802.3bj D2.1 Transmitter output jitter specification for NRZ PMDs

Pavel Zivny, Tektronix; Charles Moore, Avago

Jitter vs "Q" for PRBS30 and PRBS9 pattern

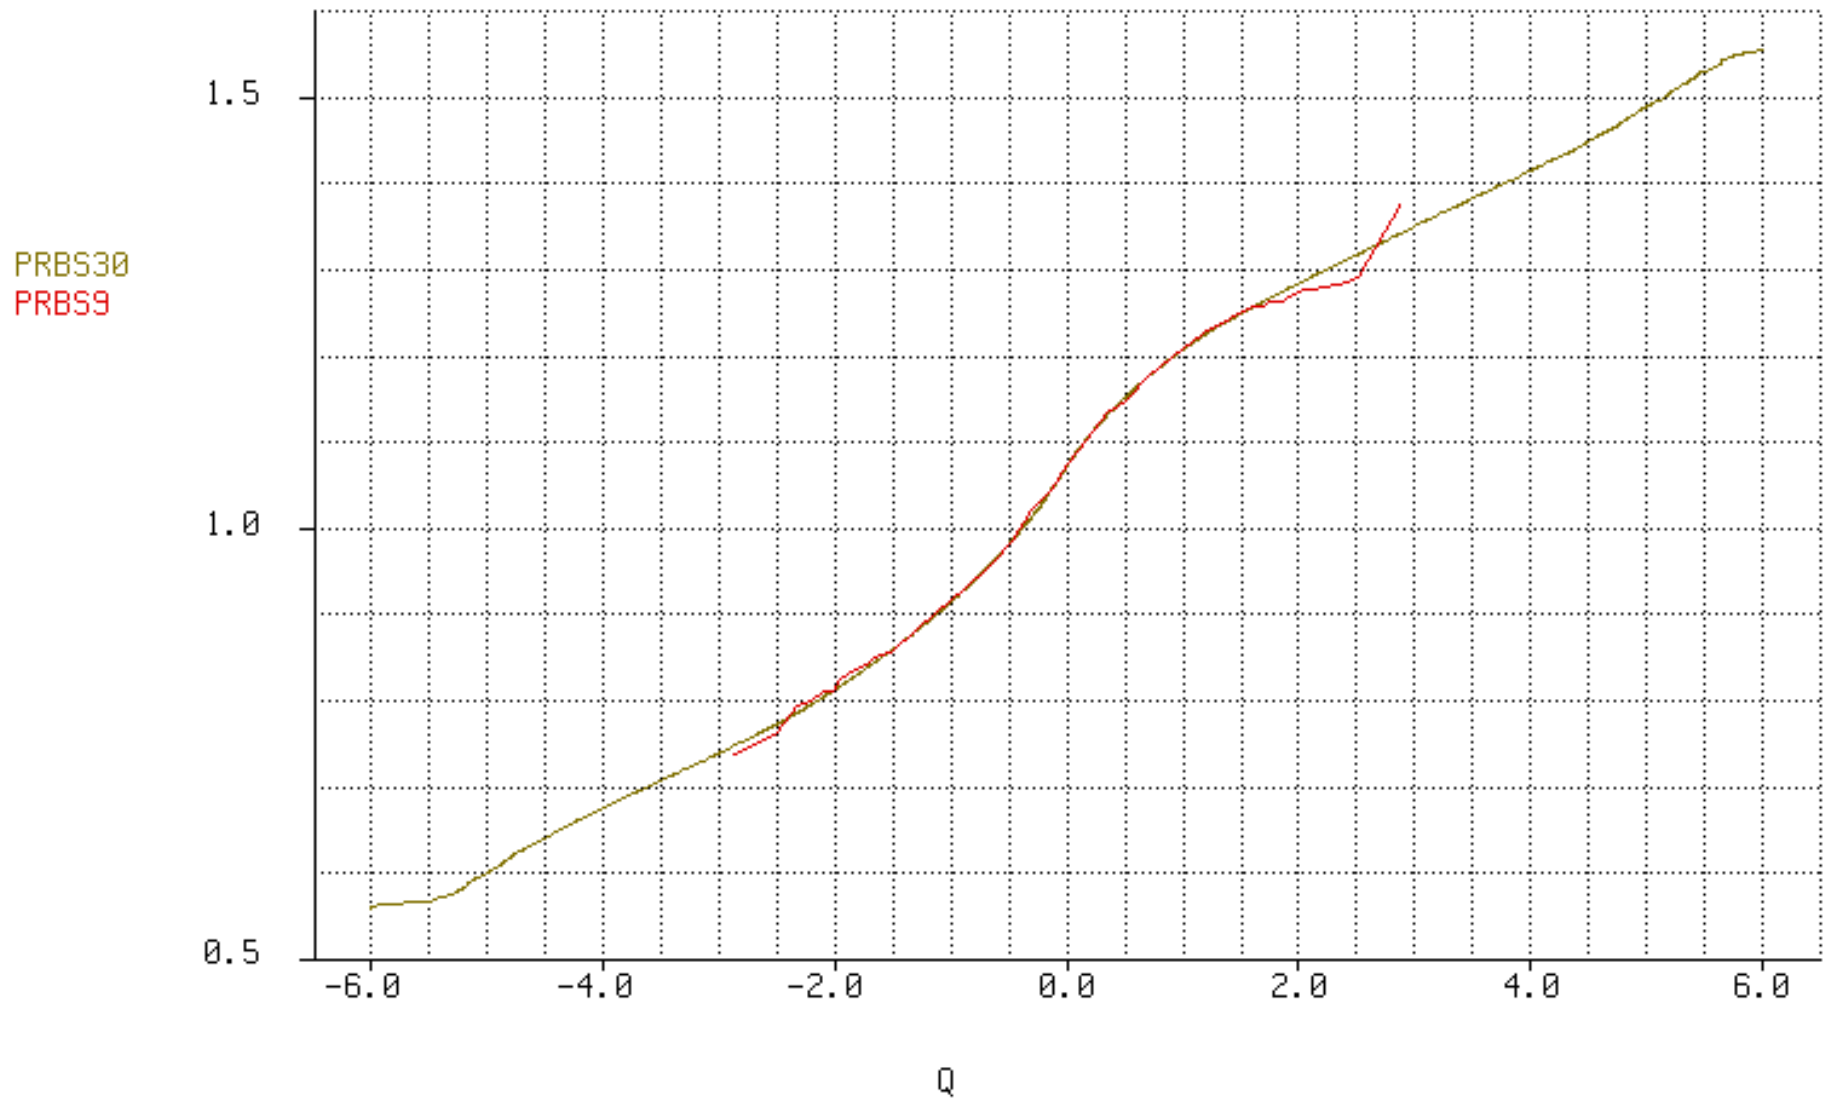
Note this plot corresponds to the right hand edge of the eye plot and that the PRBS30 eye pattern would be closed.

We then applied various rules from the jitter spec in Clause 92.8.3.9 to the data represented by the above jitter vs Q plot to extract “Total jitter excluding data dependent jitter”, “Effective deterministic jitter excluding data dependent jitter”, and “effective random jitter”.

DDJ	=	642 mUI
TJ (at 10^{-12} would actually be greater)	=	1000 mUI
J9	=	993 mUI
J5	=	774 mUI
Total jitter excluding data dependent jitter	=	358 mUI
DJ	=	236 mUI
Effective deterministic jitter excluding data dependent jitter	=	-406 mUI
effective RJ	=	764 mUI

effective RJ out of spec

TJ excluding data dependent jitter out of spec

Effective deterministic jitter excluding data dependent jitter in spec and negative

All for an ideal jitter free transmitter.
